## PRODUCT CHANGE NOTIFICATION

Date: November 06, 2015  
PCN: PCN LEDIL 112 a, b, c, d

**Subject:** **PCN 112.d – EOL notice**

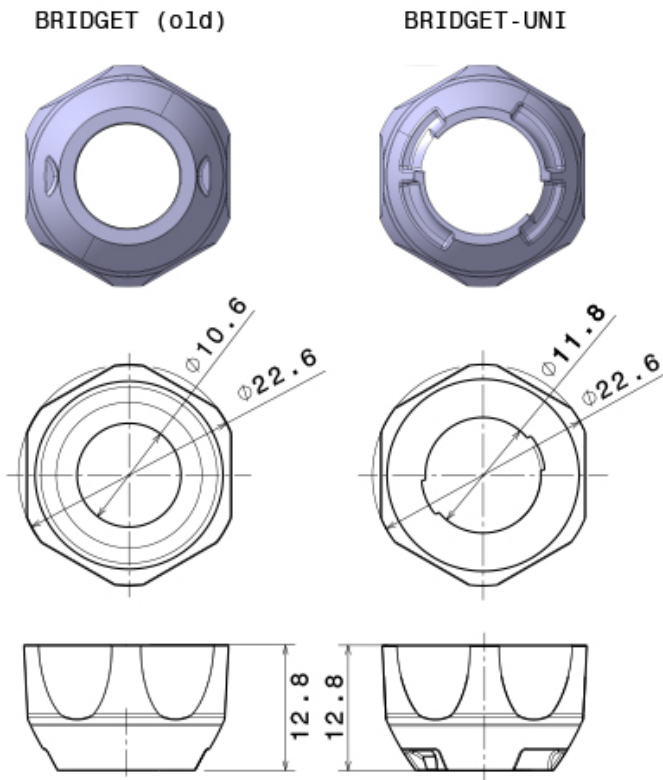
**Description:** As part of our continuous improvement process regarding the quality of our products LEDiL is planning to obsolete some BRIDGET-family reflectors and replace them with BRIDGET-UNI counterparts due the possible clash with some COBs.

**Changes:** Products will be replaced as follows.  
C10918\_BRIDGET-S → **C13557\_BRIDGET-S-UNI**  
C10919\_BRIDGET-M → **C13556\_BRIDGET-M-UNI**  
C10920\_BRIDGET-W → **C13555\_BRIDGET-W-UNI**

Mechanical and optical differences between the products:

S	S-UNI	M	M-UNI	W	W-UNI
I <sub>max</sub> (cd/lm)	1.08	<b>1.09</b>	1.18	<b>0.99</b>	0.97	<b>0.91</b>
FWHM C0-C180 (°)	41.80	<b>43.20</b>	49.80	<b>53.40</b>	60.30	<b>60.90</b>
10% C0-C180 (°)	97.20	<b>95.00</b>	80.50	<b>86.50</b>	85.20	<b>86.40</b>
LOR (%)	85.10	<b>84.90</b>	83.30	<b>81.60</b>	87.60	<b>84.70</b>
